ARKANSAS POWER & LIGHT COMPANY

Subject: Arkansas Nuclear One - Unit 2
Docket No. 50-368
License No. NPF-6
Fire Protection
(File: 2-1510, 2-2040)

Upper south piping penetration room 2084-DD

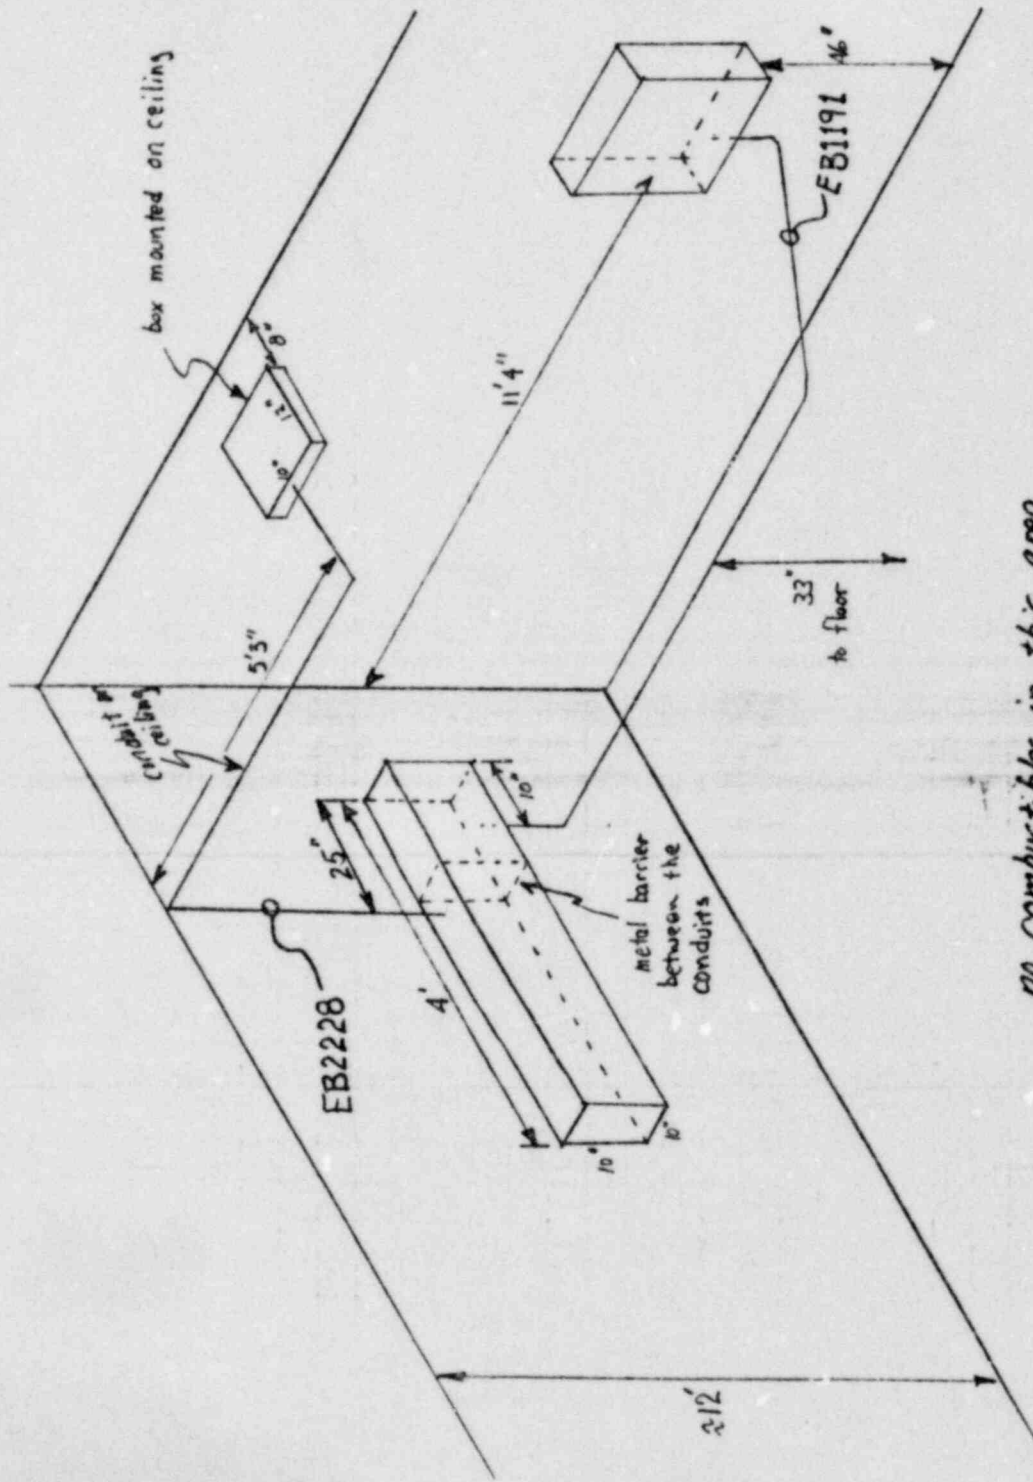
cable trays. When we made this commitment, we were under the mistaken impression that these cables were routed in proximity to each other. As shown in the attached sketch, this is not the case. EB2228 follows the ceiling and wall while EB1191 is less than three feet off the floor. For this reason we do not intend to provide fire barriers in this zone.

no combustibles in this area.
